23rd March 2021

URGENT FIELD SAFETY NOTICE MEDICAL DEVICE CORRECTION

Datascope Cardiosave Hybrid and Rescue Intra-Aortic Balloon Pumps (IABP) Cybersecurity Vulnerabilities– Ripple20

Figure 1 (back of Cardiosave Hybrid and Cardiosave Rescue unit)

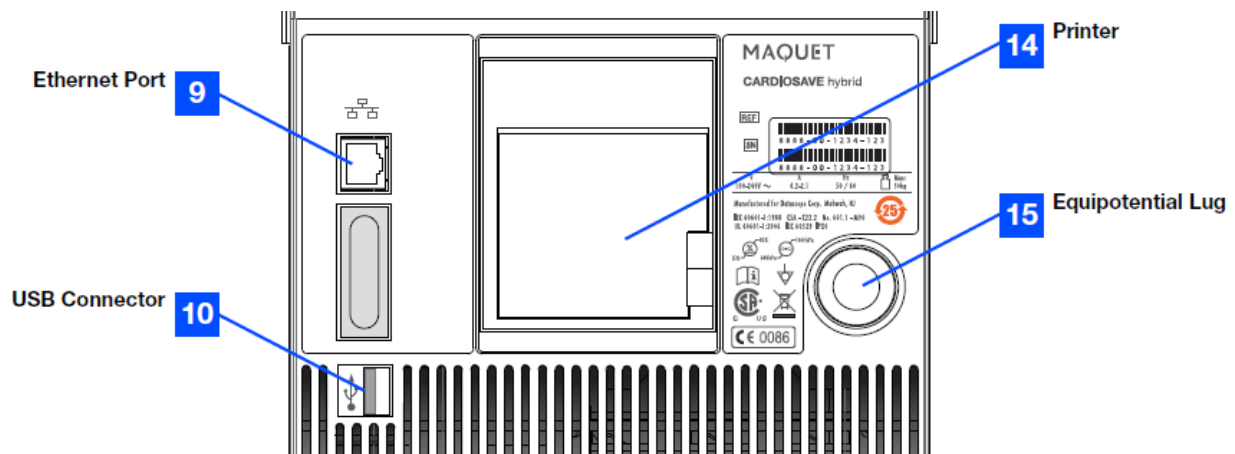
To ensure that Cardiosave Hybrid or Cardiosave Rescue are not susceptible to the Ripple20 vulnerabilities, users can disconnect the Ethernet cable from the Cardiosave Ethernet Port identified as item 9 in the image in Figure 1 below:

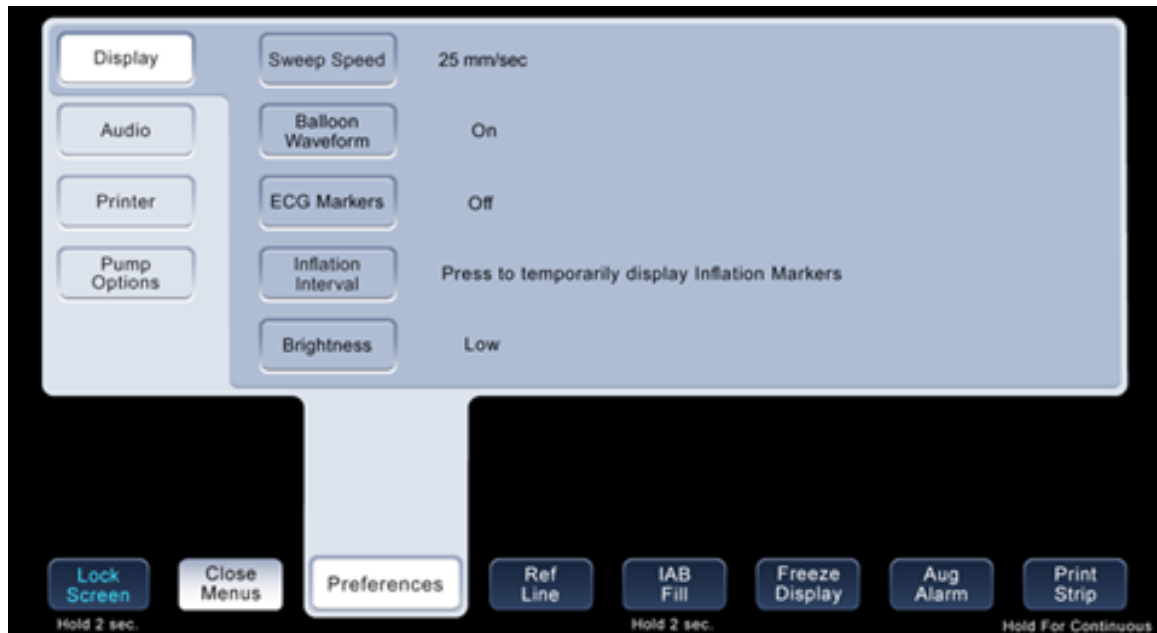
Additionally the user can turn off Network Connections via the **Network Connections** settings in the **Pump Options** menu. Ensure that the Connection Status indicator displays red after the Network Connections are set to Off.

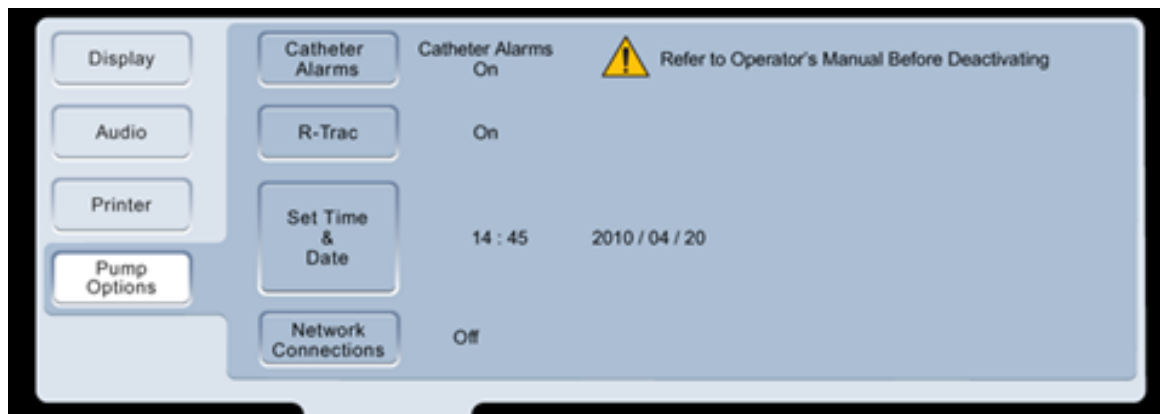
To access the Network Settings Menus first press the **Preferences** key on the bottom row of the Keypad display to display the **Preferences Menu**.

Within the **Preferences Menu** select the **Pump Options** key to open the **Pump Options** sub-menu.

With the **Pump Options** Menu open select the **Network Connections** key to access the network options.

Select the **Off** key and confirm that the **Connection Status** indicator displays red.
